Office Action Summary

10/664,371

DETAILED ACTION

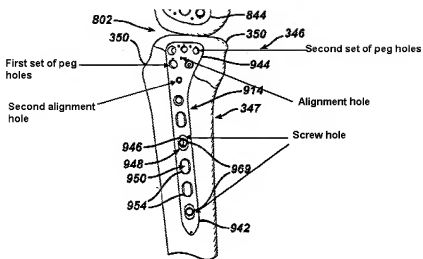
Claims 37-38, 40-43, 45-46, 48-51, 53-55, 58, 65-69, 82 and 83 are rejected under 35 U.S.C. 102(e) as being anticipated by Wack et al. (US 2004/0030339 A1).

Wack et al. disclose a plate 914 defining a first set of peg holes structurally adapted to engage a threaded head of a fixation peg and at least one non-threaded alignment hole or k-wire hole sized to receive a k-wire, the alignment hole having a second small diameter relatively smaller than each of the peg holes in the first and second sets wherein at least one alignment hole is entirely within the boundaries defined by tangent lines to adjacent peg holes (Figs. 20-22 and paras [0118]-[0162]). See a portion of Fig. 20 marked up to show features of Applicant's invention on the following page.

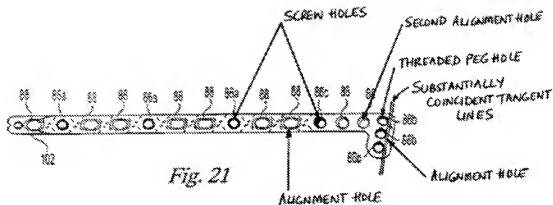
Claims 37-38, 40-41, 45-48, 51, 53-55, 82 and 83 are rejected under 35 U.S.C. 103(a) as being unpatentable over Weaver et al. (US 6,623,486) in view of Procter et al. (US 5,527,311).

Weaver et al. disclose a bone fixation plate 80 including: a head angled relative to a the shaft; the head portion defining a first set of threaded holes 86b; alignment holes much smaller in diameter than the threaded holes for provisional fixation of the bone plate; a second alignment hole 88; and a plurality of screw holes 86a in the shaft of the bone plate (Figs. 20-26, col. 6, lines 58-67 and col. 7, lines 1-17). See marked up Fig. 21 from Weaver et al. on the following page.

Weaver discloses all elements of the claimed invention except for an alignment hole located entirely between two immediately adjacent peg holes.
